## MOD5 SSD7348

### Response to Council submission on MOD5 - SSD7348, dated 9 September 2020

THIS IS A DRAFT PLAN ONLY AND IS SUBJECT TO FINAL SURVEY

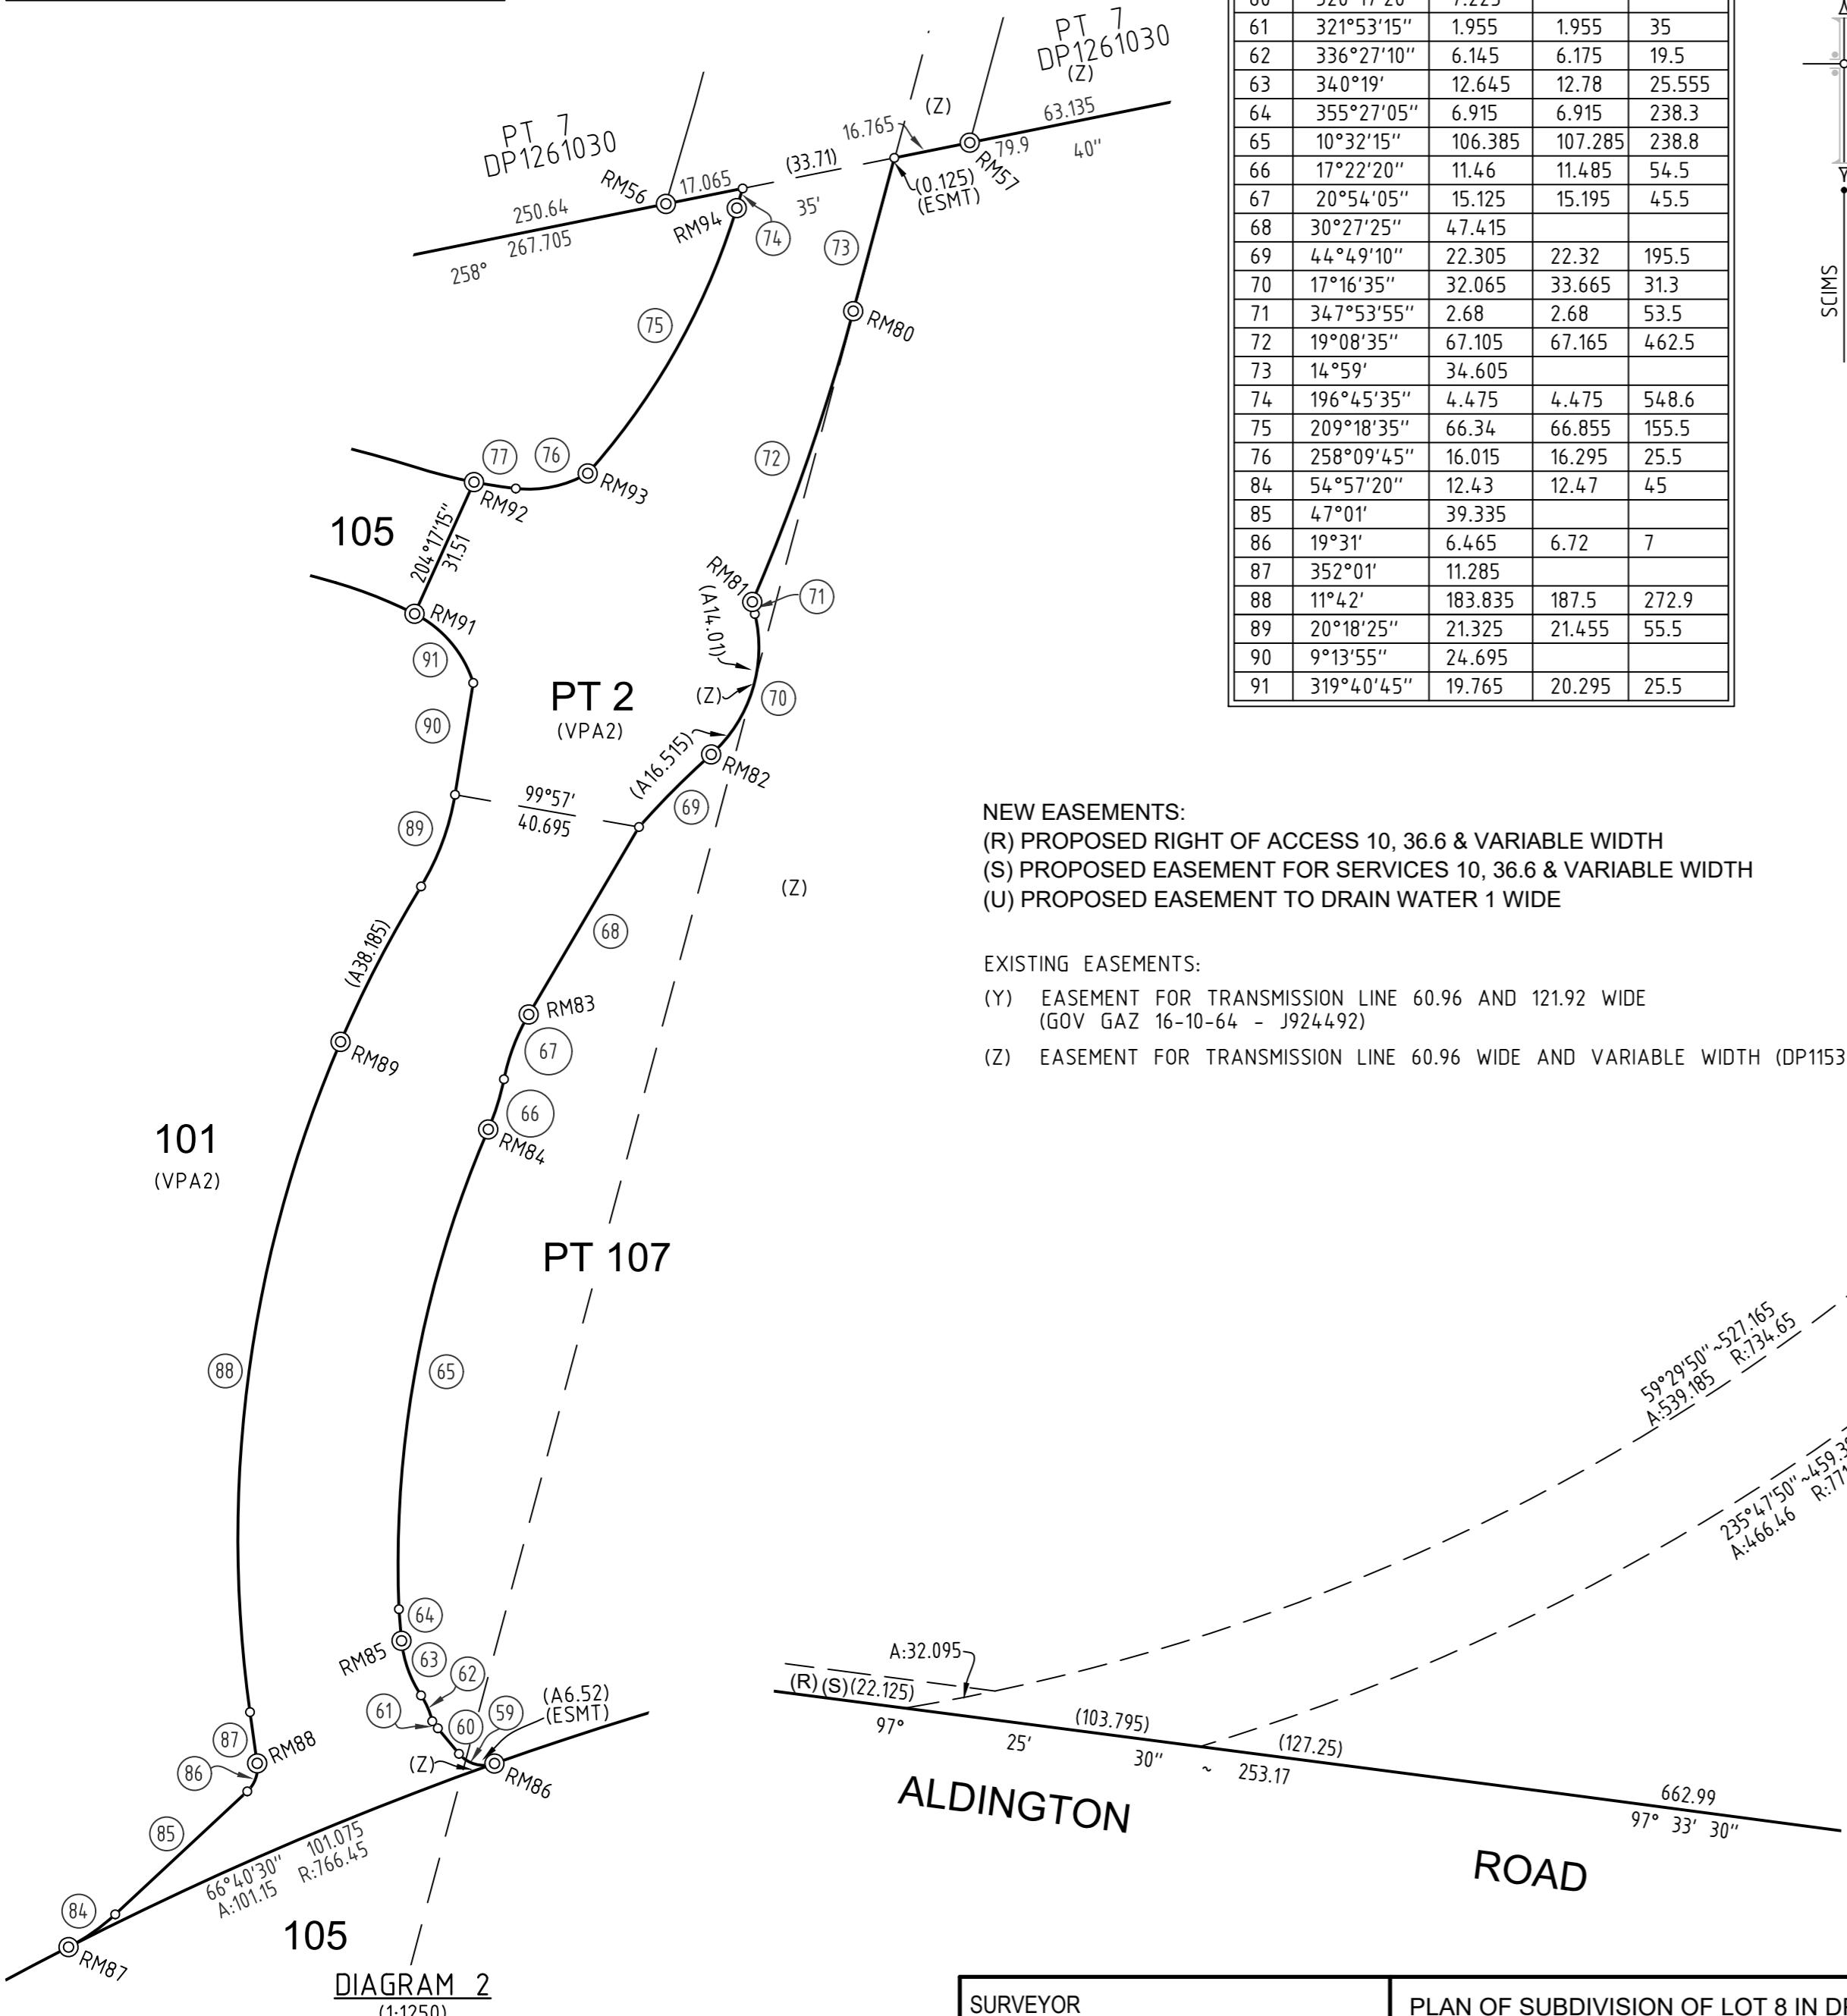
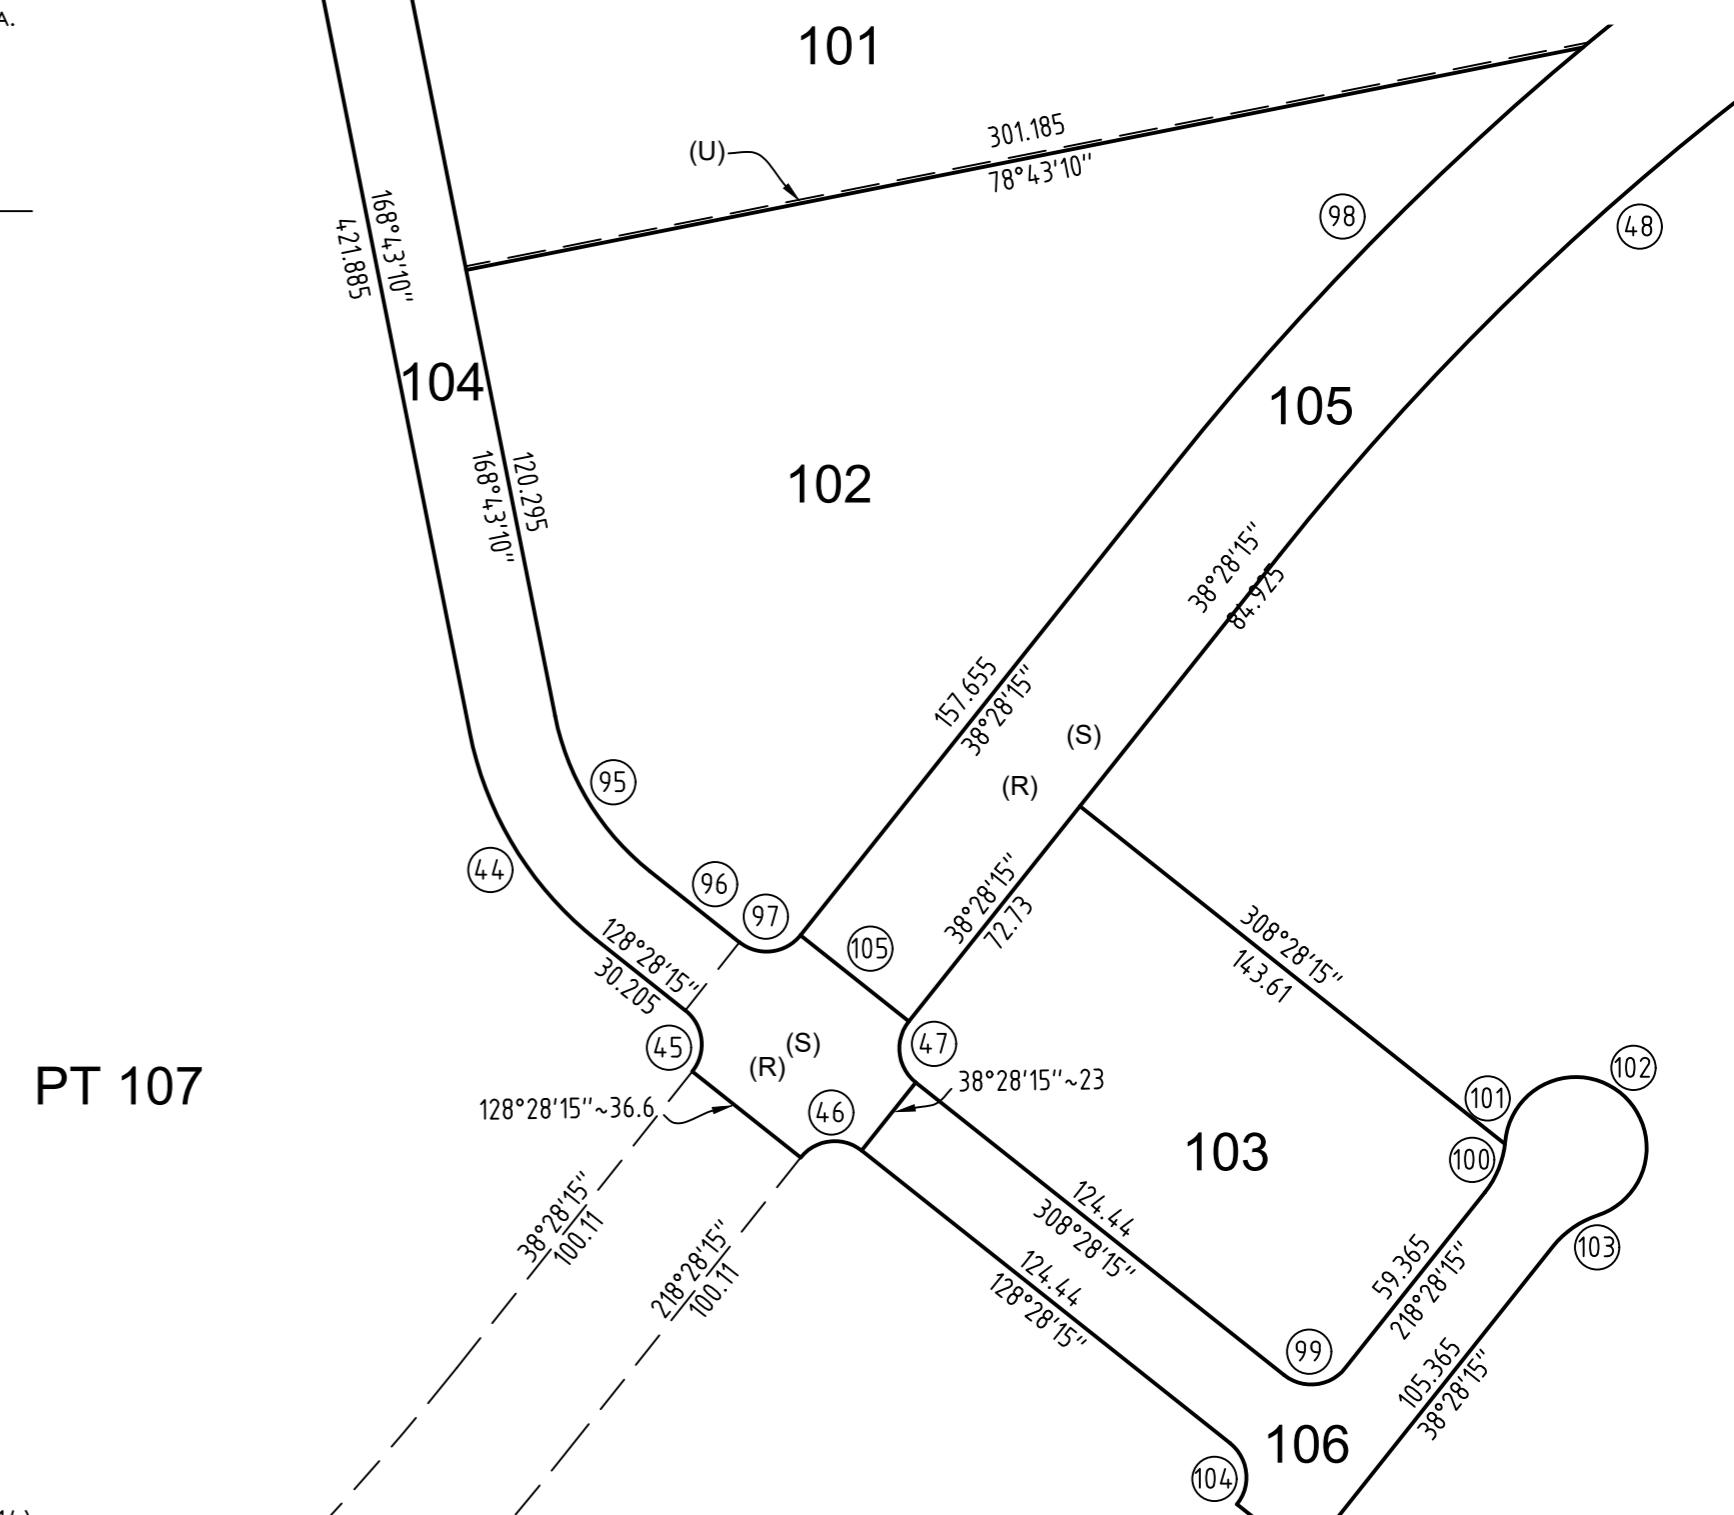
Correspondence has been recently received from TFNSW (dated 10 August 2020) that confirms that the width of the proposed southern link road allotment (proposed lot 105) is insufficient and cannot accommodate the necessary lanes required.	<ul style="list-style-type: none"><li>Goodman have responded to TrfNSW's request to increase the width of the Southern Link Road to 36.6m. Updated subdivision plans can be found within <b>Annexure B</b>.</li><li>TrfNSW has since confirmed acceptance of the subdivision plans. Refer to <b>Annexure A</b>.</li></ul>
The plans as submitted with that application have sought to widen the road reserve width beyond what was suggested in the above SSD determination, and TFNSW have now advised of further changes that are required to the proposed plans of subdivision to further widen proposed lot 105 (link road lot) to accommodate the link road intersection design requirements.	<ul style="list-style-type: none"><li>As above. The updated width of the road reserve, as requested by TfNSW, has been included in both the SSD7348 MOD5 and DA19.0575 plans.</li></ul>

As discussed, land required for Southern Link Road (SLR) does not align with the land identified in the proposed subdivision plan. The land requirement for the SLR would be a combination of purple and red line boundaries shown on the attached plan. The proposed subdivision is generally along the purple line boundary.

Please submit updated subdivision plans showing area bounded by the red line to Council for referral to TfNSW. Identification of this land on the subdivision plan is required to ensure that structures, buildings or utilities are not allowed within this land.

TfNSW Comment	Goodman Response
<b>Planning, Engineering and Landscaping Matters</b>	
The proposed Modification No. 5 to SSD Determination No. 7348 seeks to respond to an unapproved subdivision arrangement that is the subject of a current development application with Council which as yet, is not supportable by Transport for NSW (TFNSW). The assessment and determination of this separate subdivision application is dependant on endorsement of the proposed lot creation and resulting road reserve widths which have not been accepted by TFNSW.	<ul style="list-style-type: none"><li>Subdivision approval has been granted by DPIE as part of the initial SSD 7348 consent and SSD 7348 MOD 2 consent;</li><li>Goodman had lodged DA19.0575 with Council on 23 August 2019 which was prior to determination of SSD 7348 MOD 2;</li><li>Both subdivision plans have now been endorsed by TrfNSW (per <b>Annexure A</b>), albeit with proposed conditions. The latest subdivision plans that accommodate TrfNSW's comments can be found in <b>Annexure B</b>.</li></ul>

We refer to the below email, and our call this morning and confirm our discussions that TrfNSW are satisfied with the updates Goodman have made to the subdivision plan that reflect the 36.6m Southern Link Road (SLR) corridor.
